**Technify
Motors**

Service Bulletin

Service Bulletin No. / Date: TM TAE 125-0001, Revision 20 / April 17, 2018

Subject: Time Between Replacement (TBR) and Time Between Overhaul (TBO)

Fig. 1 Engine Version Identification

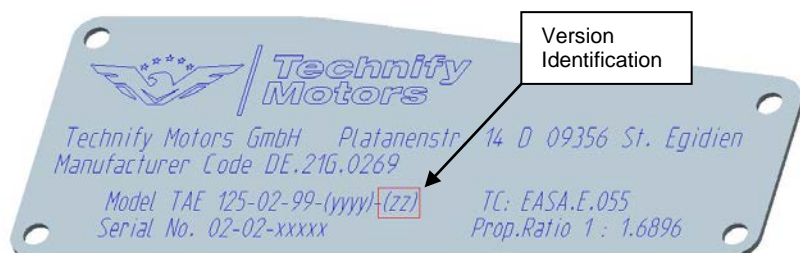
Identification of Engine Version on Type Plate:
